# Downtown Waterfront Municipal Harbor Planning Advisory Committee

Objective: To obtain feedback on the public realm and activation components of a revised Marriott Long Wharf (MLW) proposal

# Examine the revised Marriott Long Wharf proposal that is based on MHPAC Comments from May 28, 2014

### **Proposed Expansion of the Marriott: May 2014 Revisions**

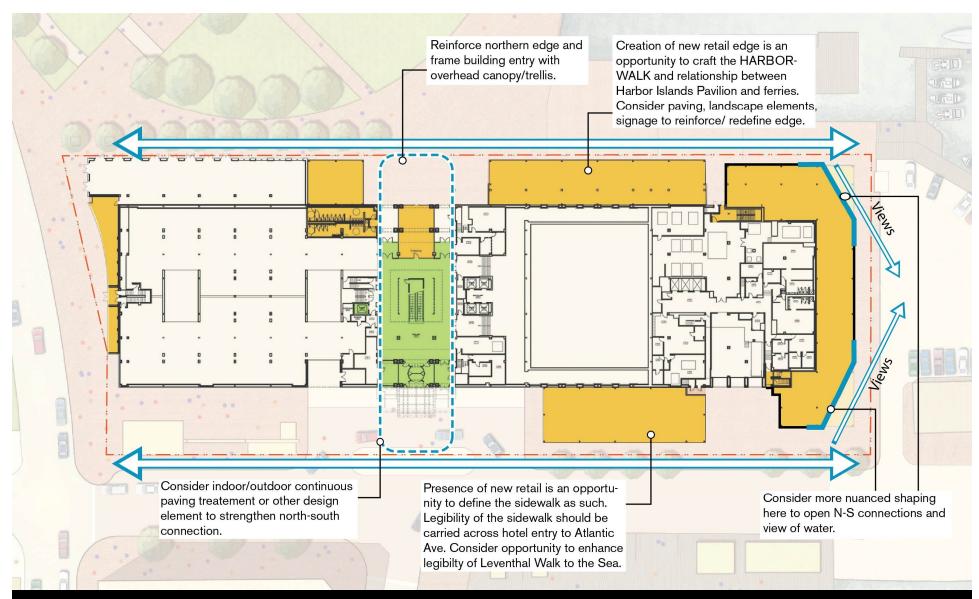
## What we heard from the MHPAC and the public

### Create Visible and Legible Links/Create View Corridor to the Water

- Concern over general extent of lot coverage, and pedestrian pinch points on north side of Long Wharf
- Open space offsets should not involve improvements to interior public spaces, rather they should relate to broader open space resources in the area such as the Greenway, CCP, and Long Wharf

### Add Ground Level Programming and Porosity

- More music and activation in the area
- New retail and restaurant must be public and function to activate the area
- Improved definition to the passageway through the hotel
- Important to maintain quiet, contemplative areas along the waterfront

~83% lot coverage

~17% open space
